UNITED STATES ENVIRONMENTAL PROTECTION AGENCY
REGION 10
1200 Sixth Avenue
Seattle, WA 98101

Re: Middle Fork Payette River Sub-basin Assessment and TMDL (HUC: 17050121)

The U.S. Environmental Protection Agency (EPA) is pleased to approve the Middle Fork Payette River TMDL submitted to us on December 31, 1998, as revised on December 23, 1999, for the following parameters:

Sub-basin Assessment and Total Maximum Daily Load for the Middle Fork Payette River

Figure 1. Sediment analysis framework.

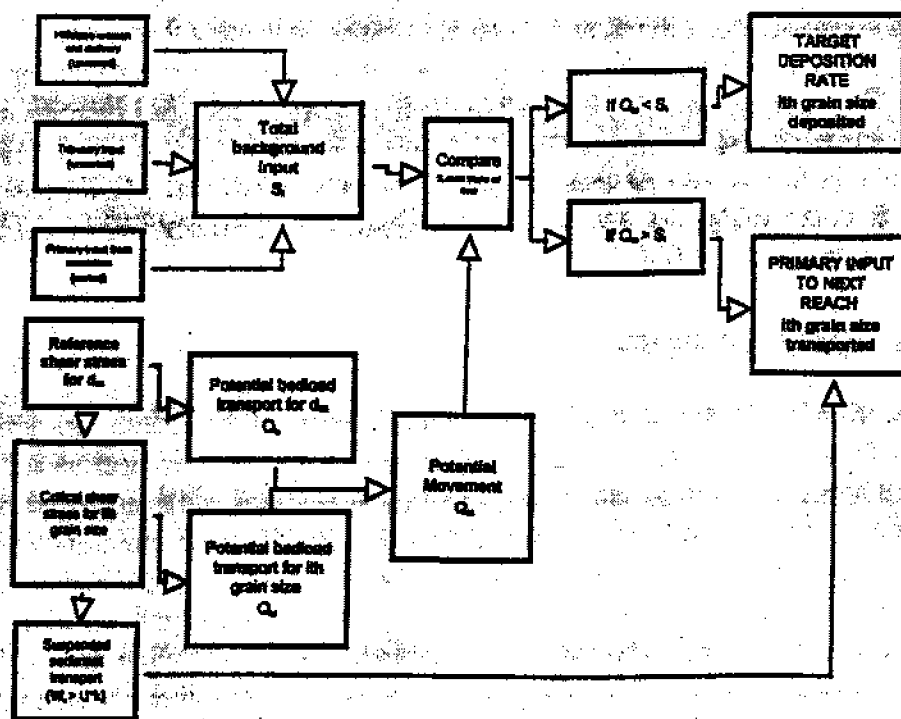
The following summarizes EPA's understanding of the analysis, to the best of our knowledge. First, the load capacity is defined in terms of a bed-material load deposition rate. The analysis assumes that water quality standards and beneficial uses will be maintained/met at a deposition rate of 50% above background, and instream targets, load capacities, allocations, and MOS are set using this assumption.

The sediment transport analysis uses sediment erosion models and bed-material transport equations. We constructed Figure 1 to illustrate our understanding of the general steps and process involved in the target and loading analyses. The TMDL analysis uses established field procedures and methods to collect data, a verified erosion model (i.e., BOISED) to define background input, and a verified bedload transport equation (Parker (1982)) to estimate the bedload deposition rate. Background hillslope erosion and delivery, and stream sediment yield are modeled using the USDA Forest Service model BOISED and a potential sediment delivery coefficient, respectively. Channel geometry, grain size distribution, and stream flow were measured in the field at seven sites. These data were input to the Parker (1982) bedload transport equation and used to estimate the sediment transport potential.

Undocumented assumptions

- 2) the bankfull discharge has remained constant since human disturbance of the watershed;
- 3) bankfull discharge only occurs once a year;
- 4) if the bankfull discharge does not move a particle of a given size fraction, then that particle remains deposited;
- 5) bedload transport occurs only at bankfull discharge;
- 6) given the three sediment inputs (Figure 1), no winnowing of fine sediment occurs on the hillslope, no selective transport occurs in the tributaries, and no particle abrasion occurs between reaches;
- 7) Parker (1982) assumes the bed material load and the pavement have similar particle size distribution;
- 8) smooth boundary conditions in the channel (Stoke's Law used for settling velocity); and
- 9) all the assumptions associated with Shield's critical shear stress apply.
